Product Update
Meritor
New 2-Piece Dust Shield for Meritor Trailer Axles

PRODUCT INFORMATION LETTER #660

Subject: New 2-Piece Dust Shield for Meritor Trailer Axles

Models: All Trailer Axles with 16.5" x 7" Cam Brakes

Figure 2: New mounting hole location

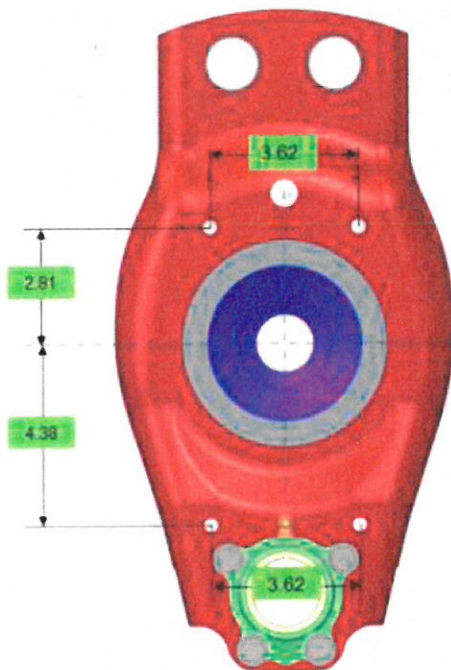
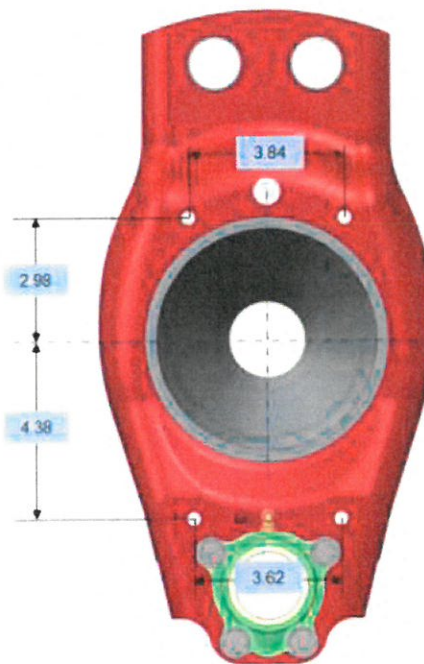
Effective immediately, all Meritor trailer axles equipped with or prepped for 16.5" x 7" cam brakes will be manufactured with brake spiders that have a new dust shield mounting hole location pattern. These changes will be managed as a revision change to our drawings; therefore, there will be no change to customer's top level part numbers or prices. All axle shipments with dust shields installed at our facility will be built using the new dust shield.

Figure 3: Part numbers of new dust shield's components

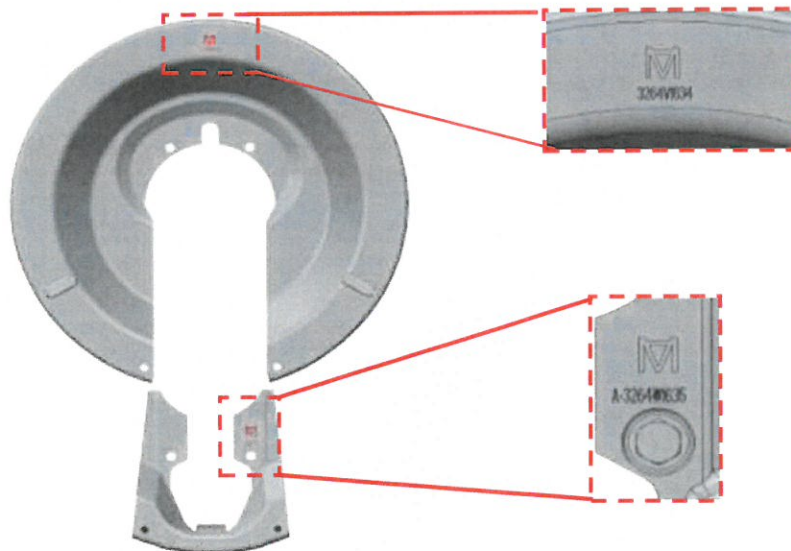
Dust shield components will have new Meritor part numbers stamped in them as shown below. The stamped part numbers will identify the individual parts in addition to the new loose kit part number.

Figure 4: Brake spider with "M6" marking

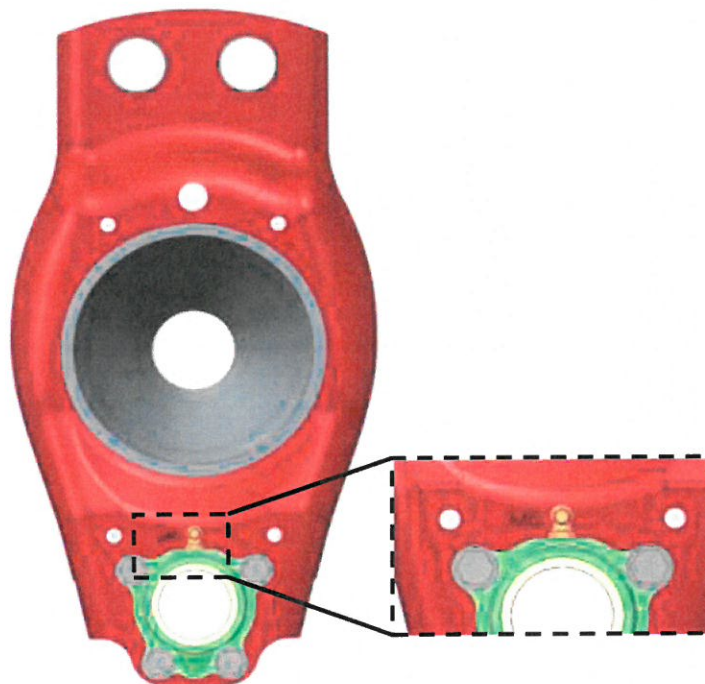
Both the current dust shield and the new 2-piece dust shield loose kit part numbers will be available for purchase from Meritor's Commercial Vehicle Aftermarket for replacement purposes. To aid in the identification of the proper dust shield kit, all axles that have "M6" stamped in their brake spiders are to be fitted with the new dust shield listed above. If the "M6" marking is not present, then the current dust shield needs to be used.
